TENNESSEE VALLEY AUTHORITY

Enclosed is our response to your letter to H. G. Parris dated February 12, 1982 regarding the request for additional information on hydrogen control for our Sequoyah Nuclear Plant. If you have any questions concerning this matter, please get in touch with J. E. Wills at FTS 858-2683.

ENCLOSURE
RESPONSE TO NRC REQUEST FOR ADDITIONAL INFORMATION
REGARDING HYDROGEN CONTROL
SEQUOYAH NUCLEAR PLANT

Figure 2.3-1

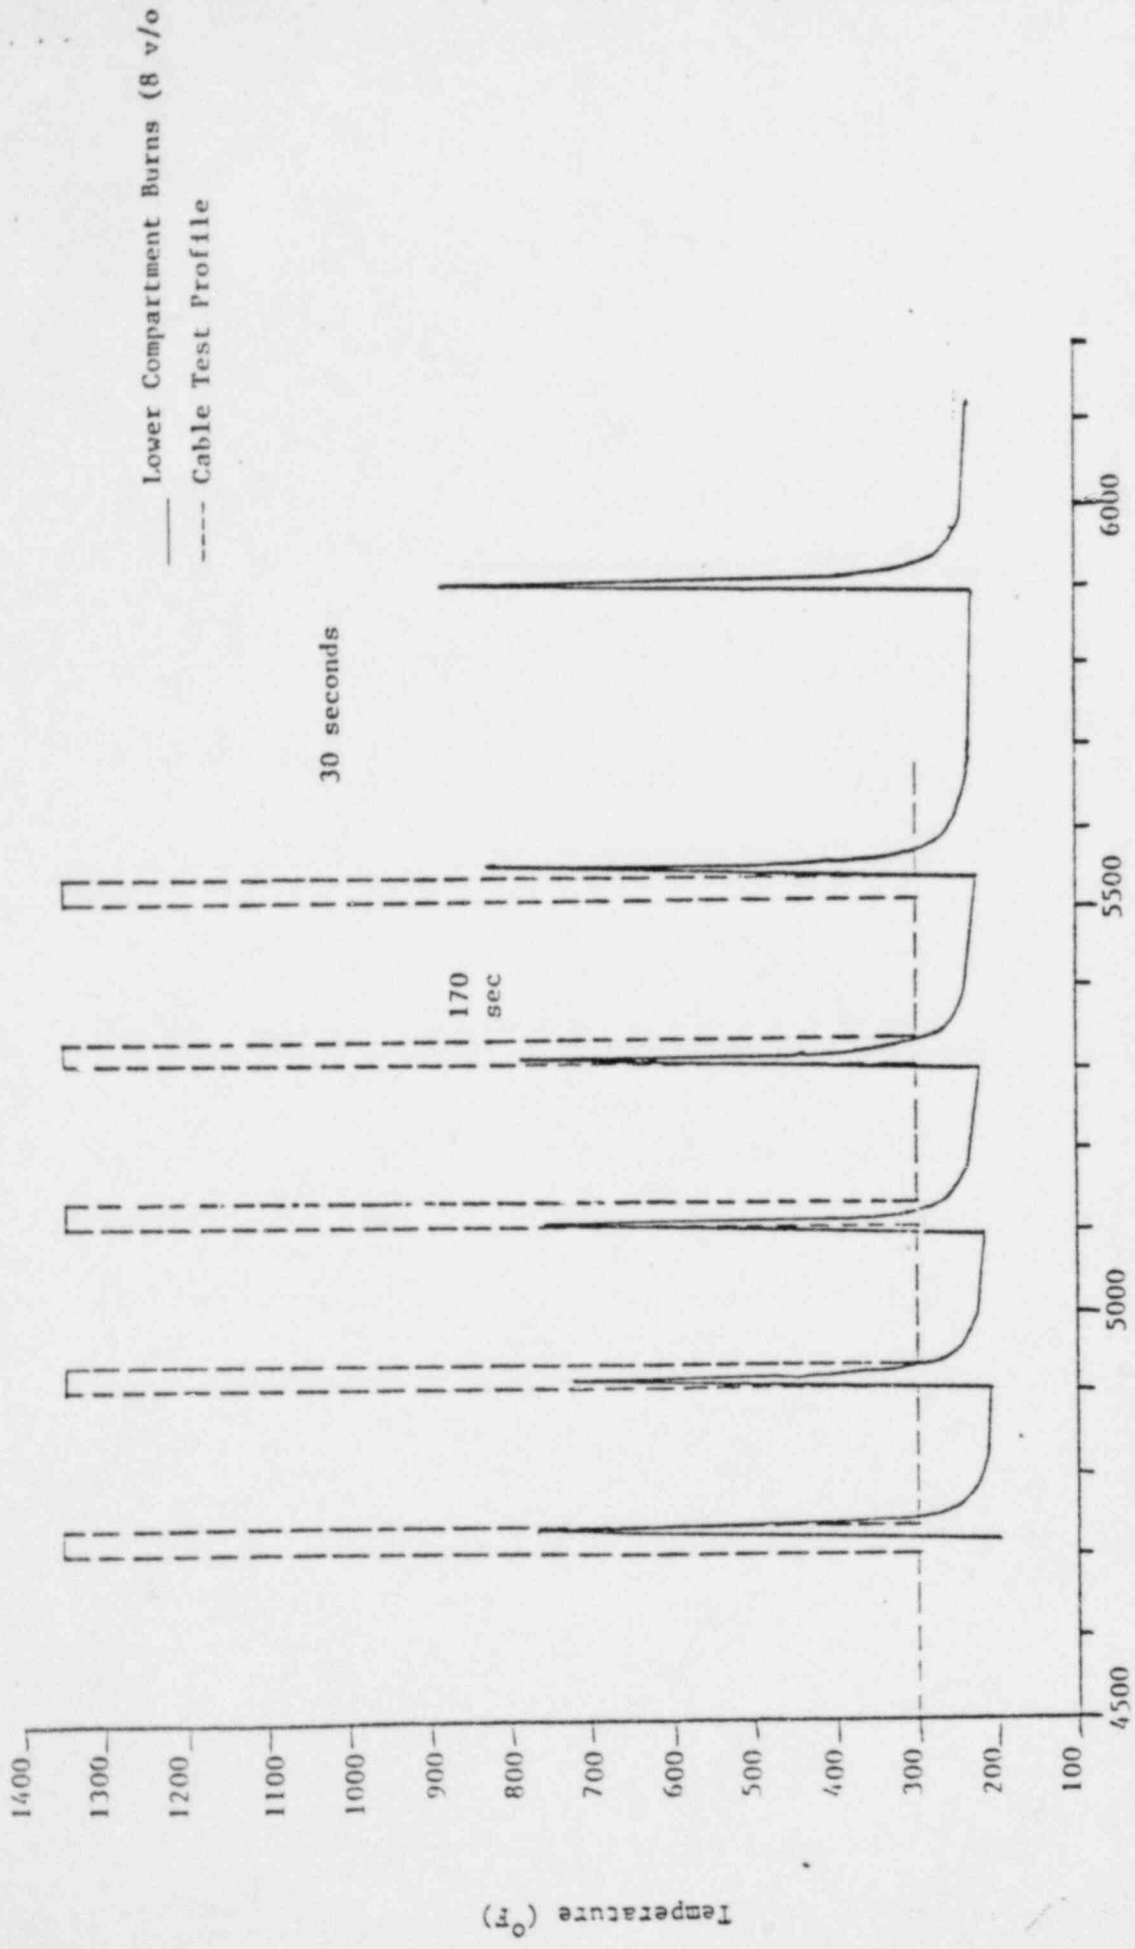
Question 7. Provide Table 2.1 and Figure 2.3-1 missing in your submittal.

Response: The requested information is provided in attachment 1.

RTD AND THERMOCOUPLE
SINGLETON TEST PROFILE
